Please note the response below to the Section 90 reply sent to the Agency by the applicant on the 26 July 2012.

Closure Restoration and Aftercare Management Plan (CRAMP)-Roche Ireland Ltd

RPS – Roche Ireland Closure, Restoration, Aftercare Management Plan (CRAMP)

Title			
SCHEMATIC HYDROGEOLOGICAL CROSS SECTION THROUGH LANDFILL CELLS H2, 1, 3 & 4			
Location			
CLARECASTLE, CO CLARE			
Client			
ROCHE IRELAND			
App'd	Reference	Date	
	EO/H/COR	AUG 2004	
TI App'd	Job No.	Scale	
	33748-024-447	AS SHOWN

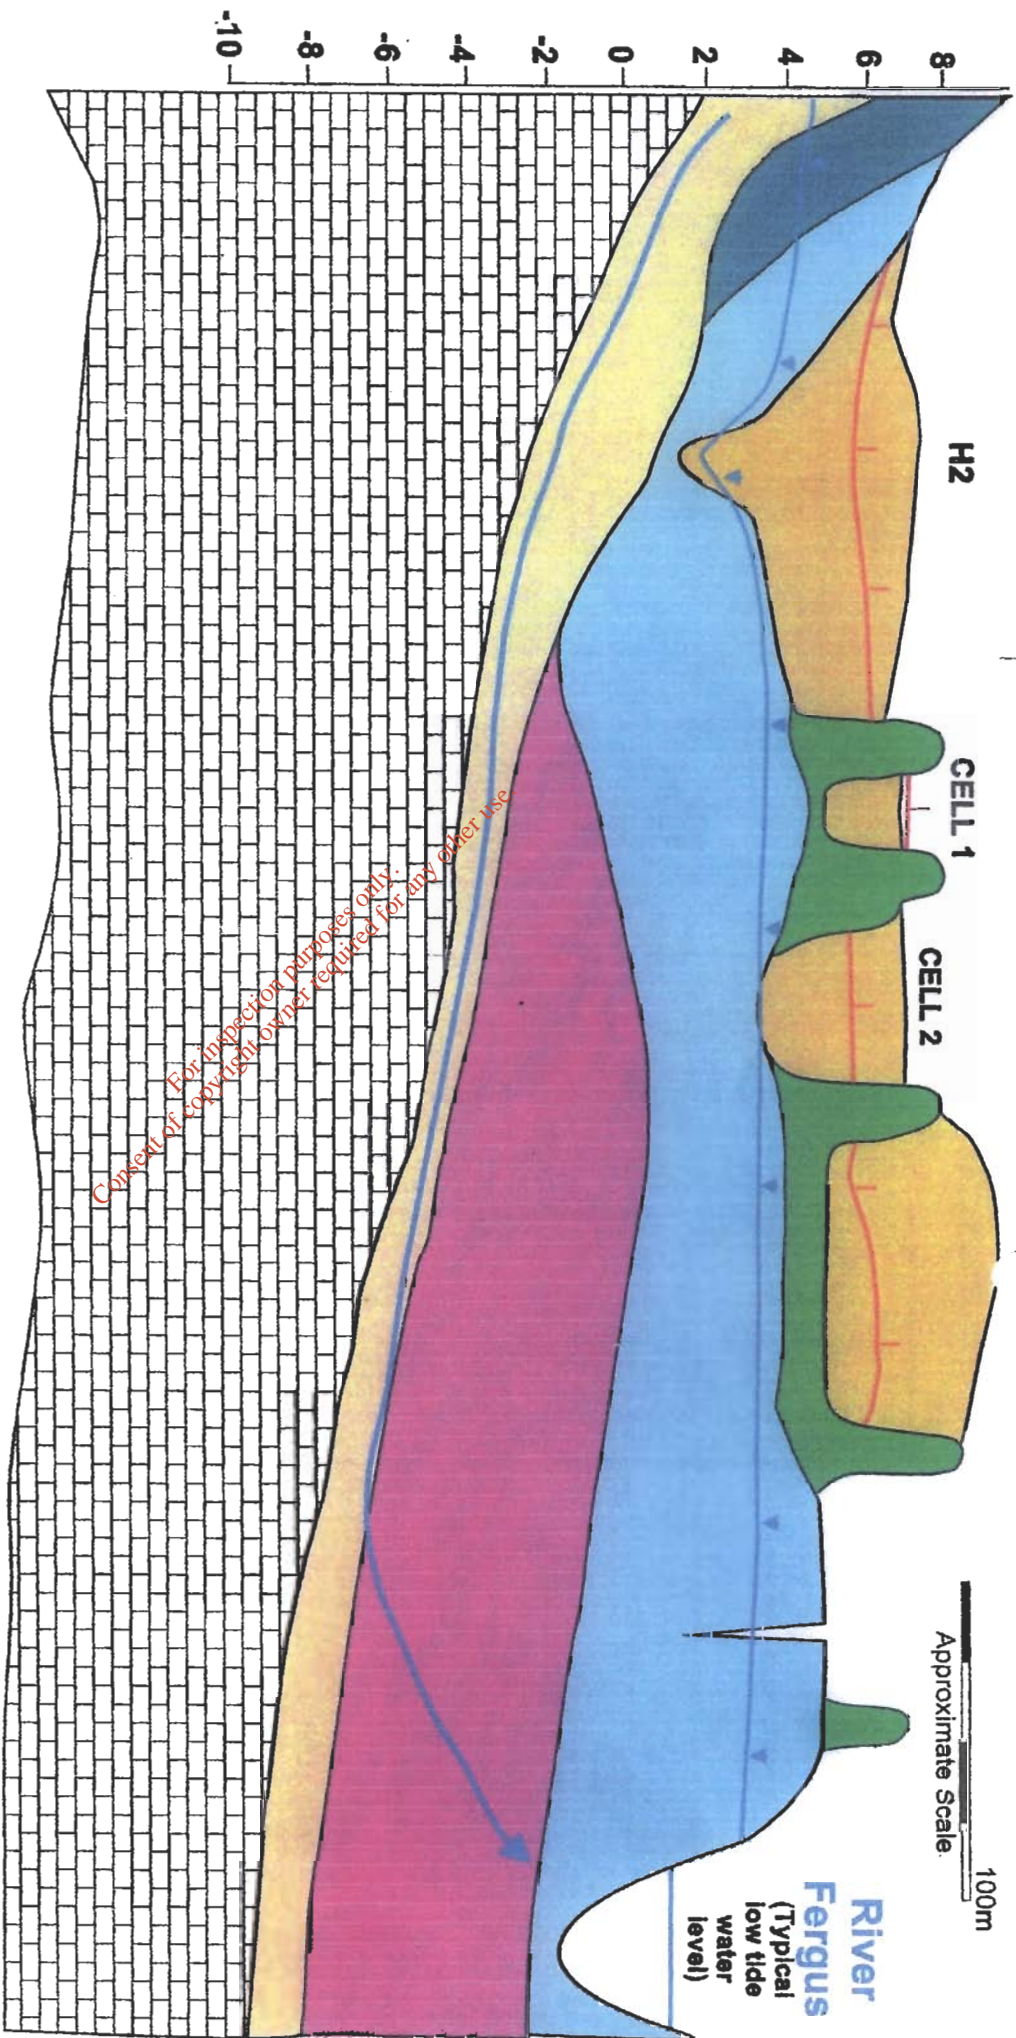
"The waste in the H2 area was deposited in unlined pits (up to 3.4m deep), with no facilities for leachate interception and collection. In some areas the wastes are emplaced below the water table (the water table was 0.85 to 2.59m below the well casing in surrounding monitoring wells in October 2004)."

"Capping of the H2 area to reduce rainfall infiltration is considered to be of limited benefit, as the chemical/process waste in some areas is emplaced below the water table and there is through flow of shallow groundwater through the waste, driven by natural gradients due to the hillside to the west of the H2 area. Capping would require considerable engineering works to profile the H2 area to promote runoff and manage the drainage, but would not eliminate the release of leachate to groundwater. In addition the presence of a landfill cap would restrict the future use of the H2 area and, despite the capital investment, would not provide Roche with a reduction of liability in the event of an unforeseen future incident".
